Access Compliance Report

Public Rights-of-Way

Intersection ID: 14278	Main Street: ROMARE_BEARDEN_DR	Cross Street: FARMER_ST	Location:	S
ADA ID: D49F1F87B4D0	Ramp Type: MedianPerp	Initial Pass/Fail: Fail	Overall Compliance: No	Severity Score: 25
Codes/Mitigation Info/Possible Solution		Field Measurements/Component Compliance

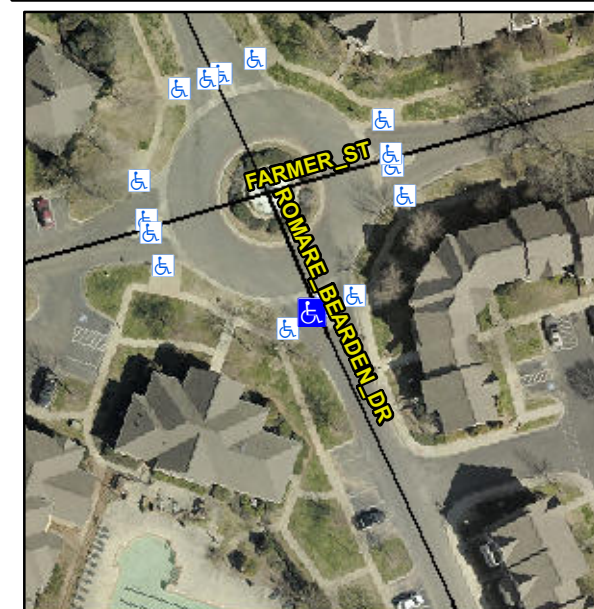
Not Found, R304.2.2, R304.5.3

Compliance	Description	Data	Compliance	Description	Data
N/A	Ramp Length (in)	35.0	No	Ramp Slope (%)	9.0
Yes	Ramp Width (in)	54.5	No	Ramp XSlope (%)	5.9
N/A	Flare Type LT	N/A	N/A	Flare Type RT	N/A
N/A	Flare Slope LT (%)	N/A	N/A	Flare Slope RT (%)	N/A
N/A	Flare Traversable LT?	N/A	N/A	Flare Traversable RT?	N/A
N/A	Landing Length (in)	N/A	N/A	DWS Provided?	N/A
N/A	Landing Width (in)	N/A	N/A	DWS Contrast?	N/A
N/A	Landing Slope (%)	N/A	N/A	DWS Length (in)	N/A
N/A	Landing X Slope (%)	N/A	N/A	DWS Full Width?	N/A
N/A	Landing Curb? (Y/N)	N/A	N/A	DWS Offset (in)	N/A
N/A	Shared Landing?	N/A			
N/A	Gutter Ponding?	N/A	N/A	Gutter Slope (%)	N/A
N/A	Gutter Lip Ht (in)	N/A	N/A	Gutter X Slope (%)	N/A
N/A	Painted X Walk1?	No	N/A	Painted X Walk2?	N/A
	X Walk 1 Direction	To W		X Walk 2 Direction	N/A
N/A	X Walk 1 Width (in)	N/A	N/A	X Walk 2 Width (in)	N/A
	X Walk 1 Slope (%)	2.1		X Walk 2 Slope (%)	N/A
	X Walk 1 X Slope (%)	1.2		X Walk 2 X Slope (%)	N/A

Remove & Replace Entire Ramp.
